HUMAN FACTORS EVALUATION OF THE
STANDARD NUCLEAR UNIT POWER PLANT SYSTEM
(SNUPPS)

Nuclear Projects, Inc.
5 Choke Cherry Road
Rockville, Md. 20850

Essex Corporation
333 North Fairfax Street
Alexandria, Virginia 22314

From September 1980 to February 1981, the Essex Corporation of Alexandria, Virginia performed a human engineering evaluation of the Standard Nuclear Unit Power Plant System (SNUPPS) for Nuclear Projects, Incorporated. Data were collected from two sources: the Westinghouse simulator at Zion; and the as-built control boards at the Callaway site. The evaluation employed human engineering assessment techniques developed by Essex Corporation specifically for power plant control room design reviews. These techniques were developed while writing NUREG/CR-1580 for the NRC and subsequently were refined during control room reviews for other utilities.

FIGURE 9
SECTIONALIZED CC

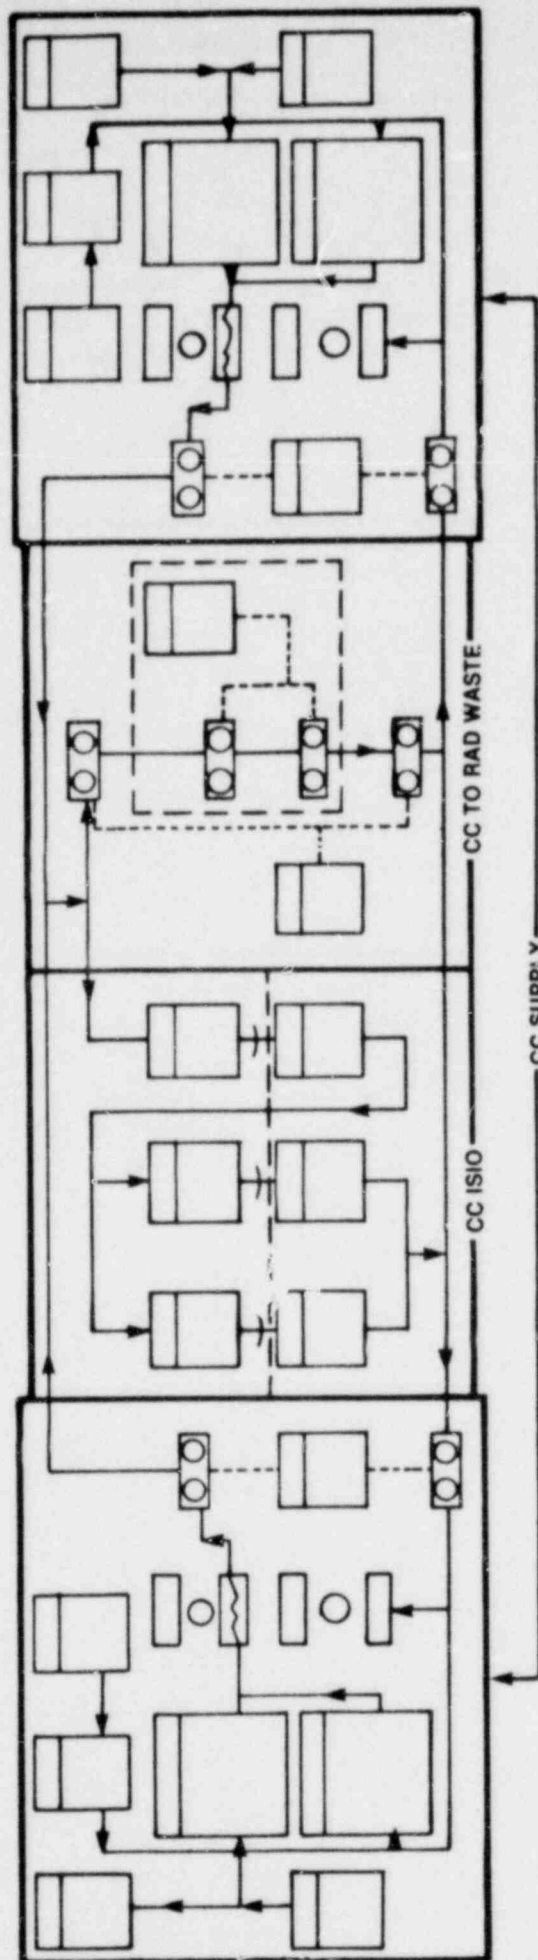
Only the two outboard sections (Trains B and A supply) are mirrored (see Figure 9). CC is also heavily mimicked. In addition to being mirrored, which is demonstrably poor design, the mimicked portions of CC are segregated by nonmirrored (or "nonmirrorable") functional groups, increasing the level of difficulty and unreliability of use. The following are means (ranked in order of HFE preference) to reduce or eliminate these difficulties:

FIGURE 10
COMPONENT COOLING REDESIGN CONCEPT

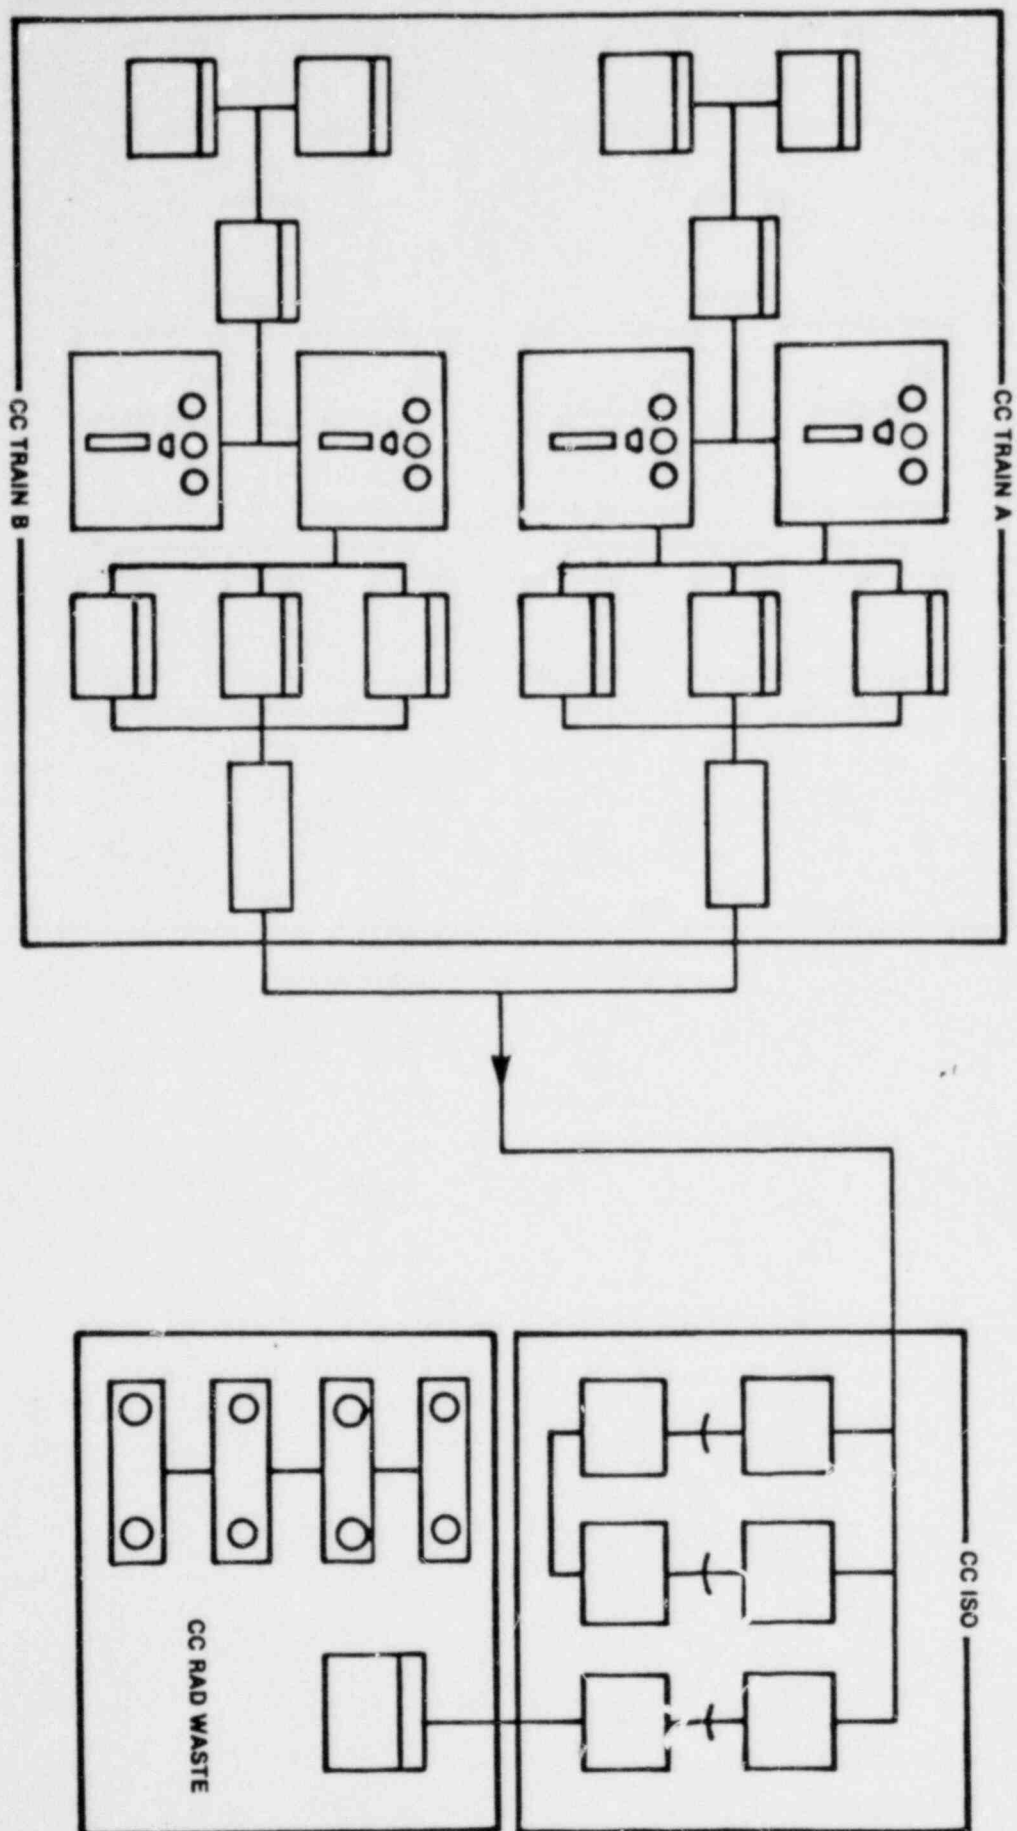
Figure 10 contains a concept whereby this can be done. Note that the details of layout are not accurate in Figure 10, which is only provided to demonstrate a good HFE design concept that does not contain mirror images. Each train of CC supply is identical in layout.

2. Identify groups by means of demarcation or background coloring. Given that CC is heavily mimicked, lines of demarcation may add excessively to visual clutter. However, background coloring increases the number of color meanings in the CR, a situation which is also to be avoided.

FIGURE 11
SNUPPS ENGINEERED SAFEGUARDS SYSTEM

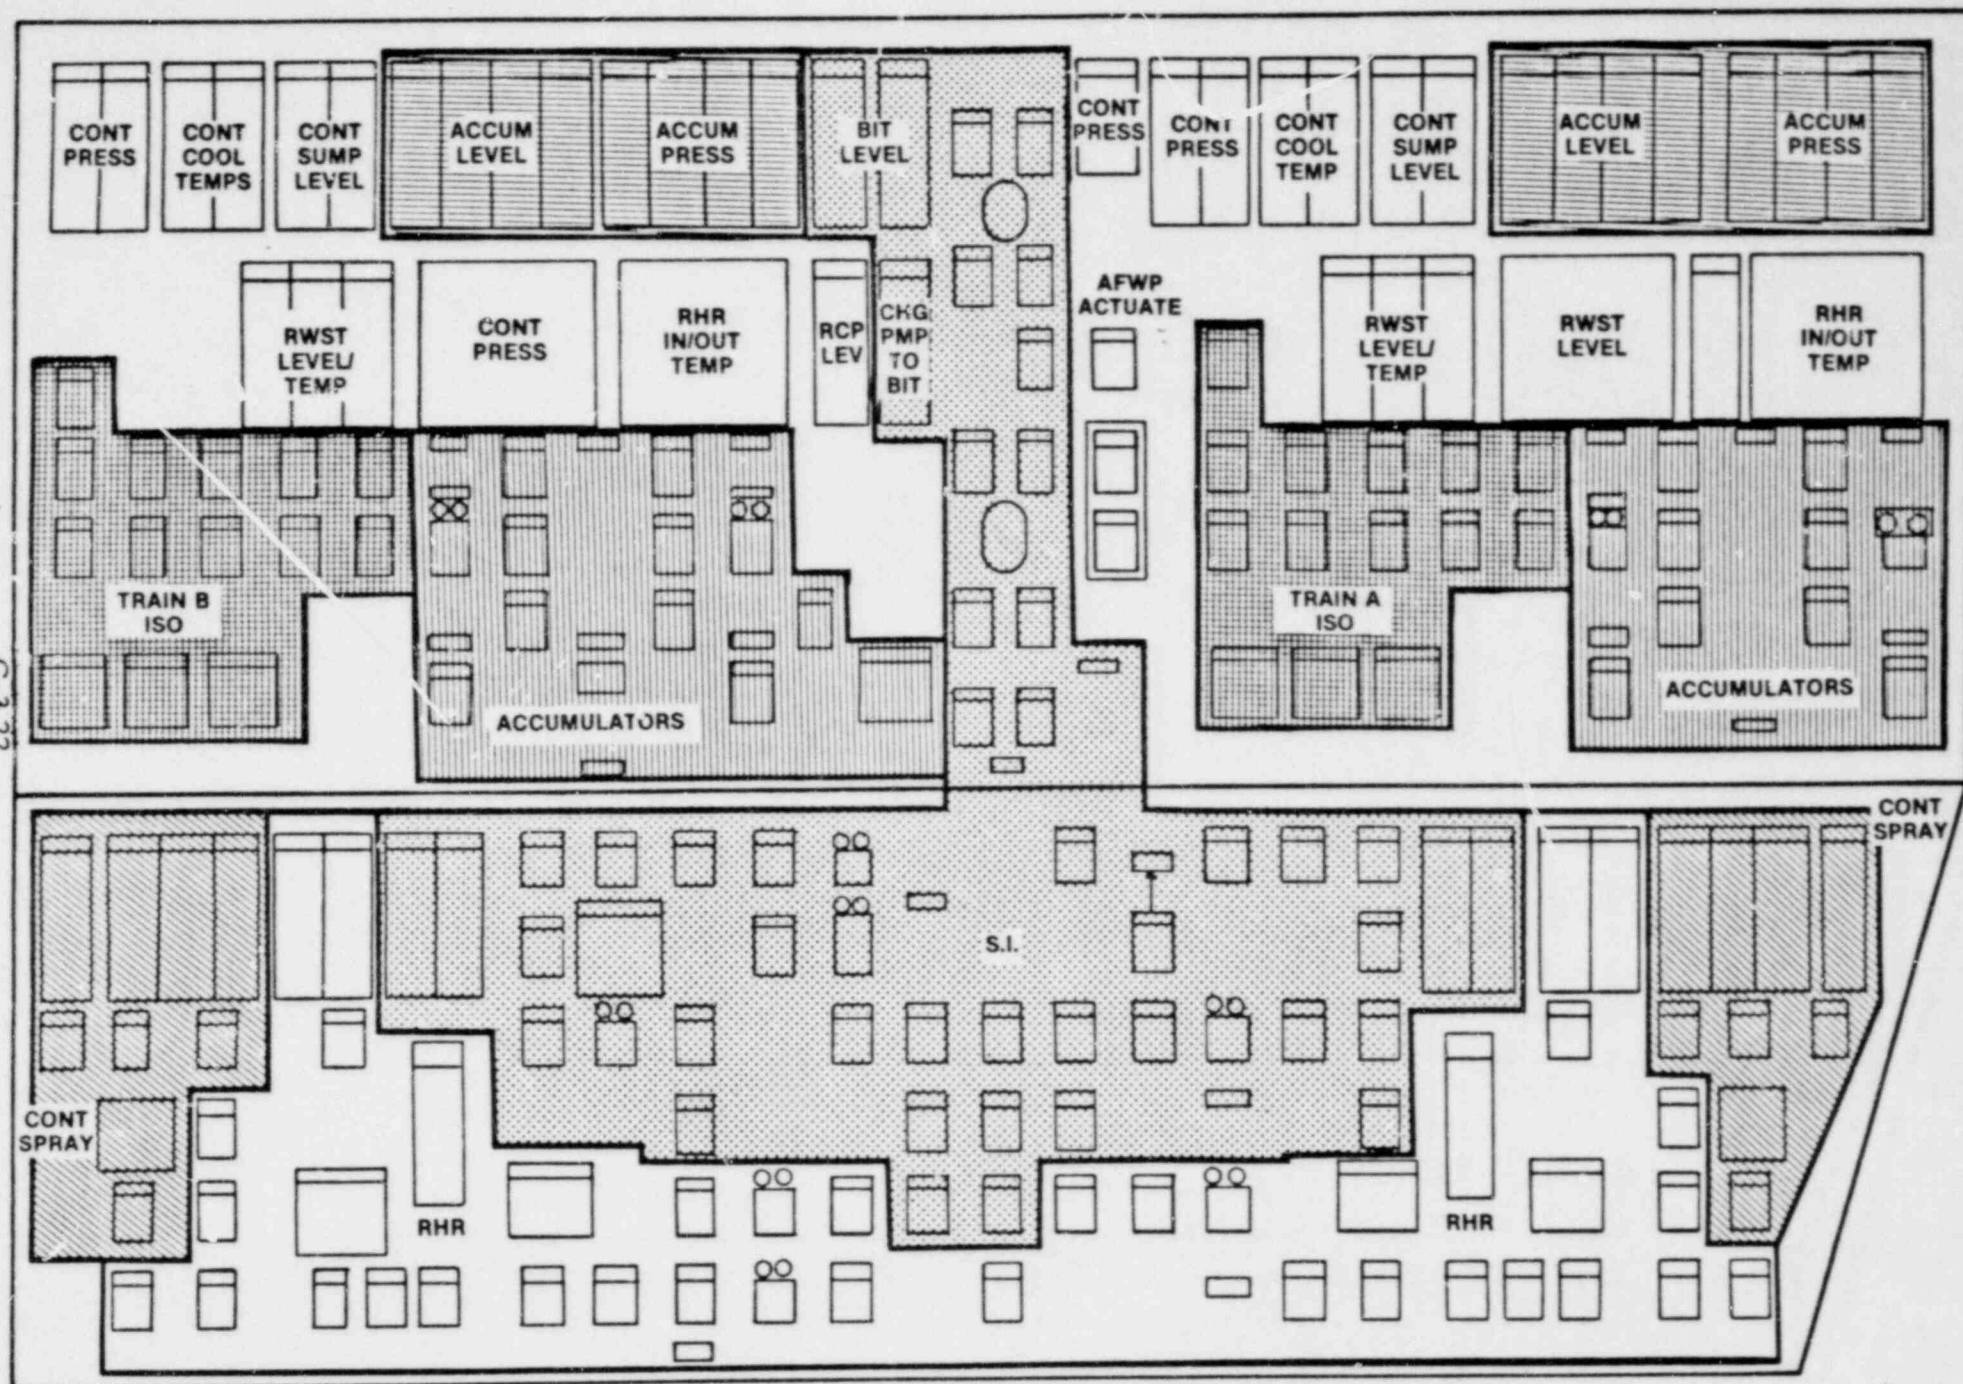
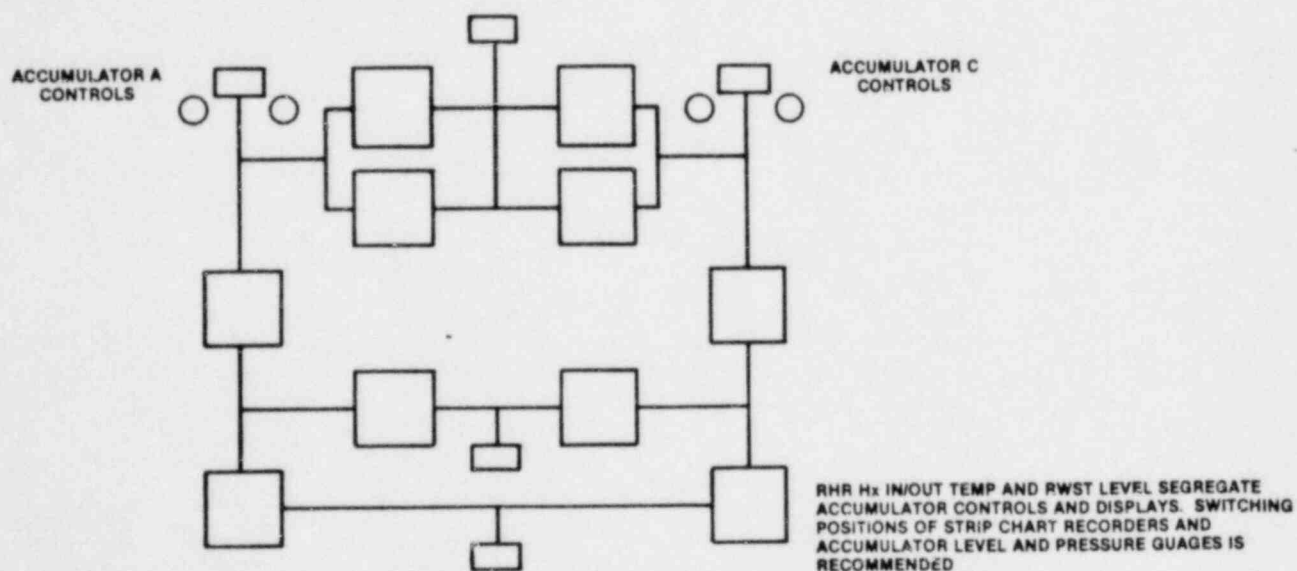
D) Engineered Safeguards. Probably the worst instances of mirror imaging in the SNUPPS CR, from a human factors viewpoint, is the engineered safeguards panel. This panel is a sort of a cross design with both mirror imaging and identical design layouts being employed (see Figure 11). The following are true in relationship to the safeguards panel:

- Controls for RHR and SI are mirrored, but the displays are not
- Containment spray, RHR, and SI are basically mirror imaged, while Phase A & B isolation and accumulator controls are not
- Of the four accumulators, B and D are grouped in a mimic design, as well as A and C. These two groups are not mirrored with regard to one another, but the two accumulators within a group are mirrored (see Figure 12).
- All of engineered safeguards systems are mimicked
- Functionally correspondant controls and displays are separated up to five feet due to the mirror image design.

The following recommendations are made regarding backfitting this panel:

1. It is highly recommended that the panel be redesigned without incidences of mirror imaging, since:

FIGURE 13
HIGHLIGHTED CONTROL GROUPS

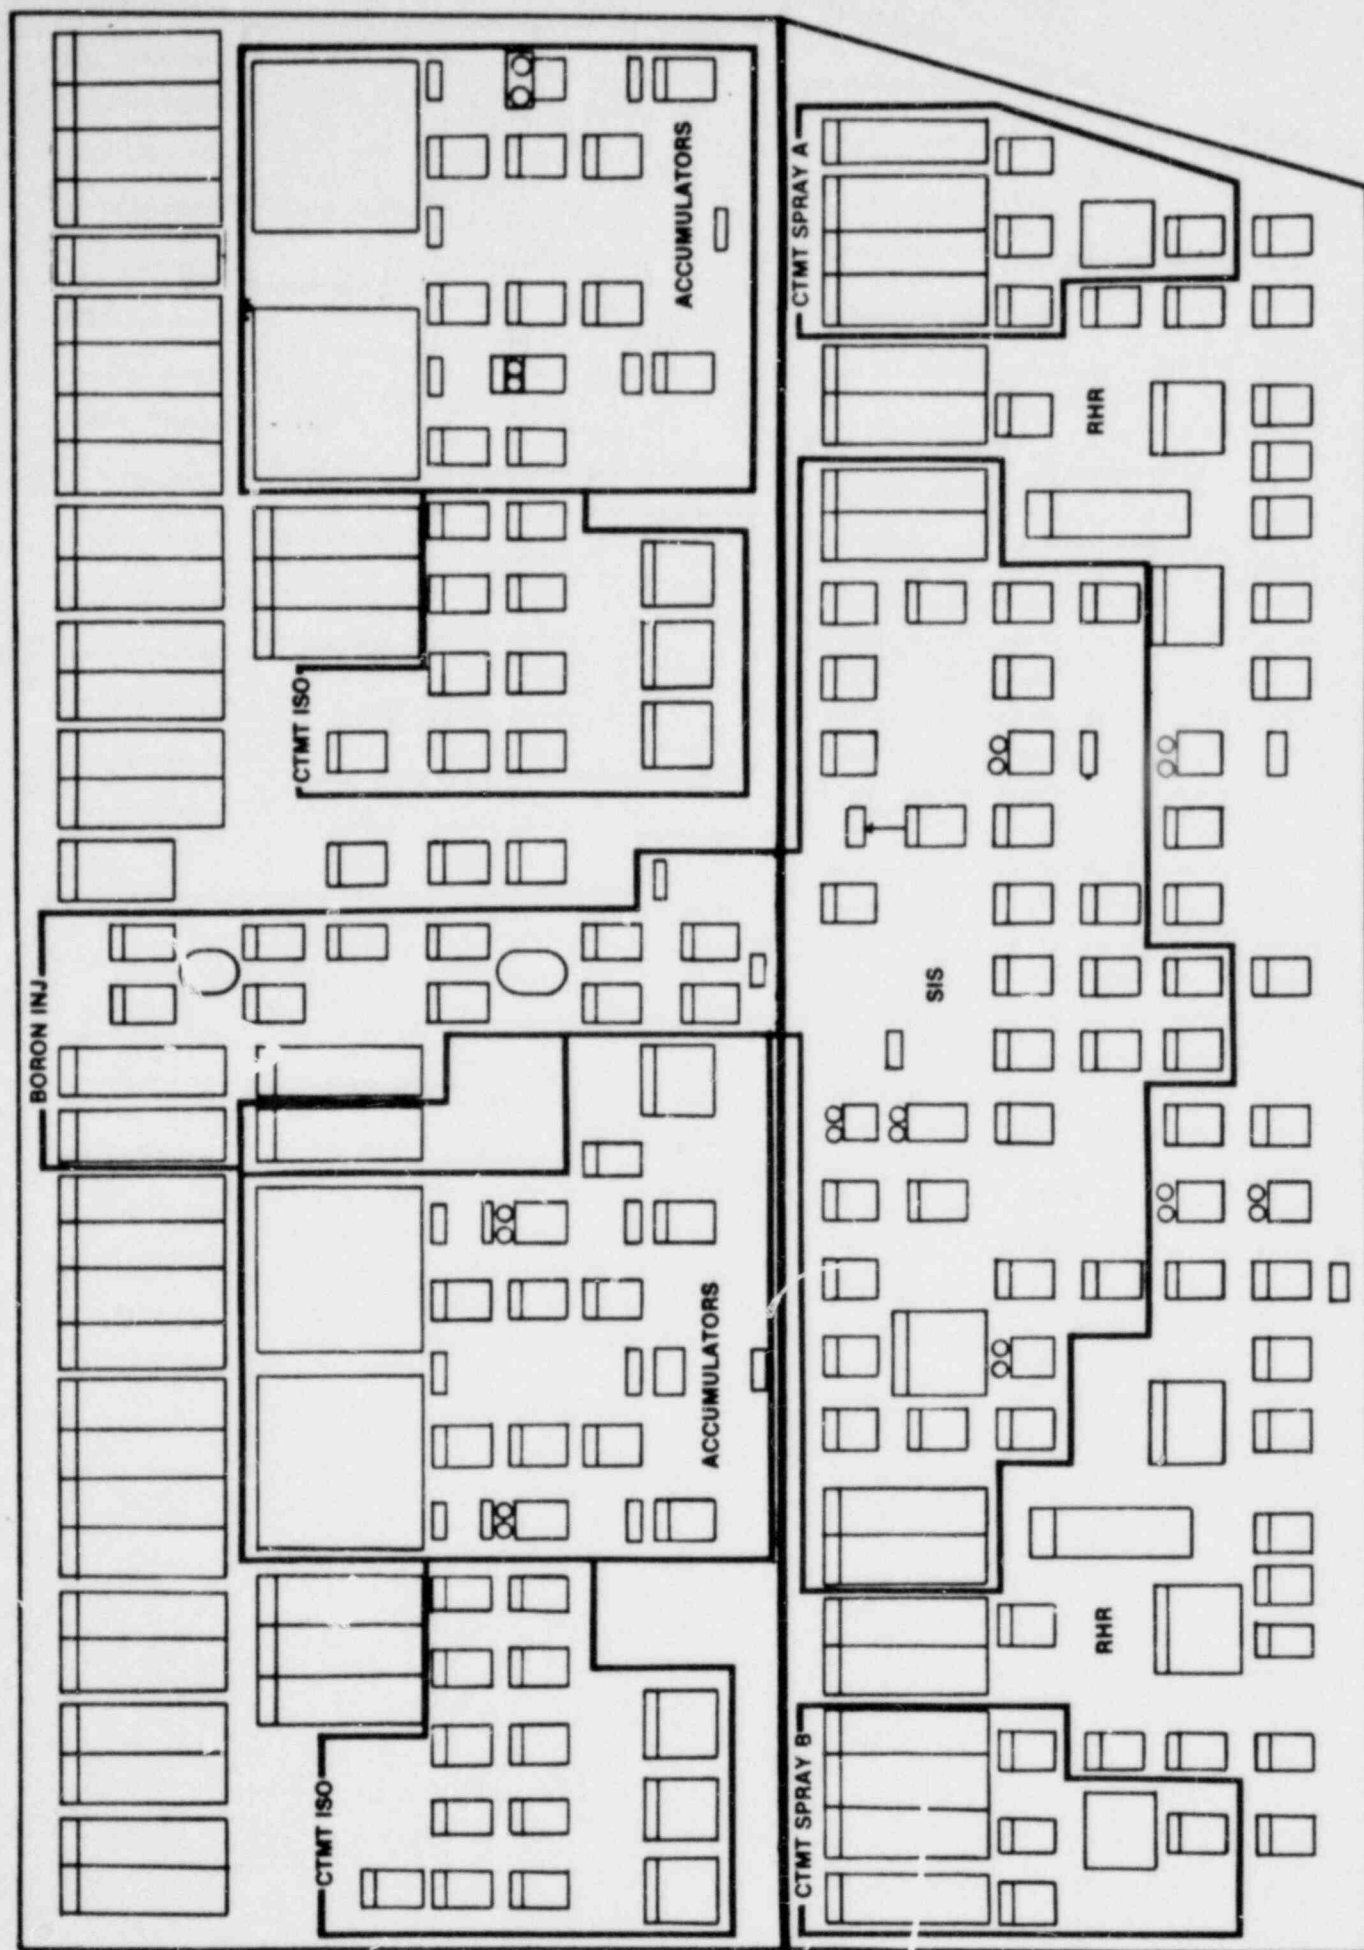
Also, provide summary labelling for each system (see Figure 13).
